Product Change Notification (PCN)

Modular Jack

Change Notification: **PCN-US-20150907-Modular Jack**

Description of changes: **Change of Production Location
Change of New Tools
Change of Part Numbers**

Previous part number	New part number	Drawing number
A-2014-3-4-R	A-20140	ASS_2885_COrev02

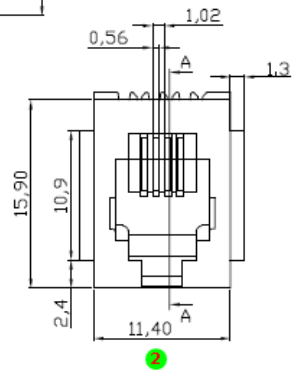
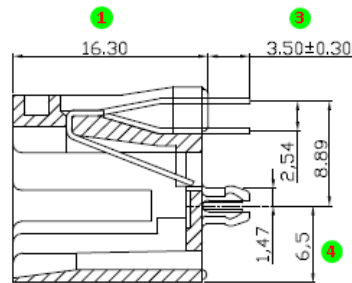
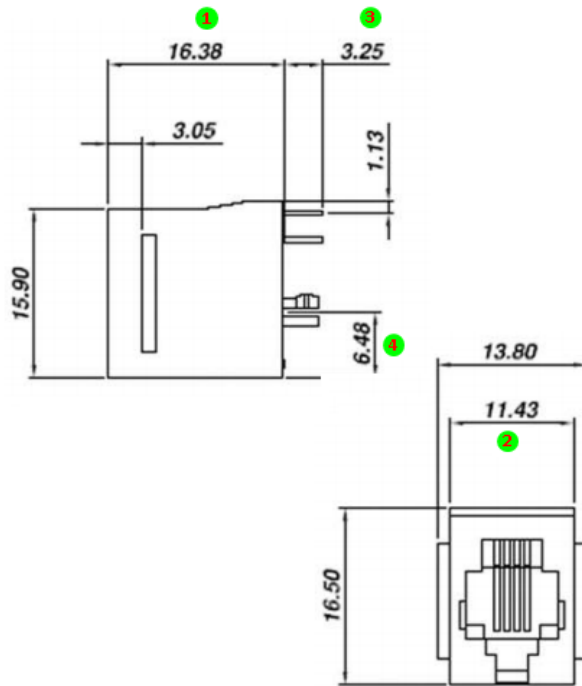
1. Amendment of the specification
2. Change of dimensions, see sheet 3
3. Listed drawing # replaces all prior drawings, see sheet 2

A-2014-3-4-R
Old version

A-20140
New version

- 1)16.38
- 2)11.43
- 3)3.25
- 4)6.48

- 1)16.30
- 2)11.40
- 3)3.50
- 4)6.5
